NOTICE OF VIOLATION

On May 21, 2024, Energy Safety conducted an inspection of PacifiCorp's WMP initiatives in the vicinity of the city of Seiad Valley, California. The inspection report is enclosed herewith. Energy Safety found the following violation:

INSPECTION REPORT

Electrical Corporation:	PacifiCorp			
Report Number:	PC_RMA_20240521_1101			
Inspector:	Romeo Marroquin Ajcac			
WMP Year Inspected:	2023			
Quarterly Data Report (QDR) Referenced:	Quarter 4 (Q4)			
Inspection Selection:	Energy Safety viewed the contents of the Q4 QDR and performed an analysis that resulted in the selection of			
	the WMP initiatives and locations referenced in this report.			
Relevant WMP Initiative(s):	Expulsion Fuse Replacements (2023 WMP initiative number 8.1.2.12)			
Date of inspection:	May 21, 2024			
City and/or County of Inspection:	Seiad Valley, Siskiyou County			
Inspection Purpose:	Assess the accuracy of PacifiCorp's QDR data, completeness of its work, compliance with WMP requirements,			
	and compliance with its protocols.

Item7IA1Img1: Overall view of one expulsion fuse and one Cal-Fire exempt fuse

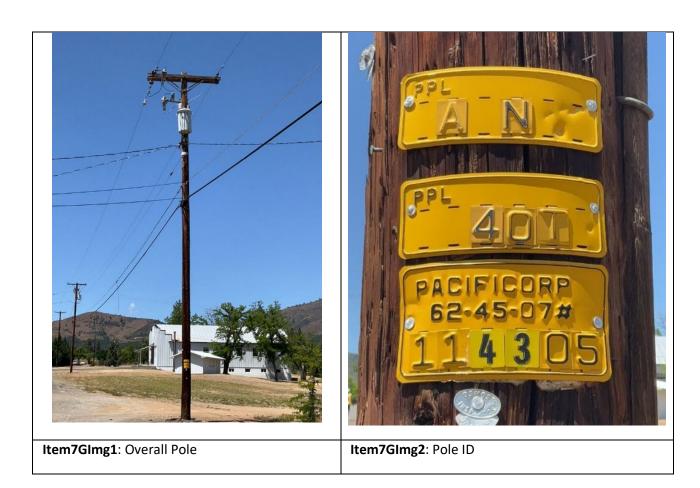
Energy Safety arrived at the provided pole ID 06245007.0114305 at Grider Creek Rd, Seiad Valley, CA, 96086, 41.8340426149584, -123.207217491406 and observed that one of the fuses in place is a non-exempt expulsion fuse. The inspector's observation is documented in Violation 1 photographs, which are attachments to this report. Photo numbers Item7IA1Img1, and Item7IA1Img2 depict a non-exempt expulsion fuse.

- 1. The reported location provided by PacificCorp indicated that work on the Expulsion Fuse Replacements initiative (8.1.2.12) was reported as completed.
- 2. The subject pole has a non-Cal Fire exempt expulsion fuse.
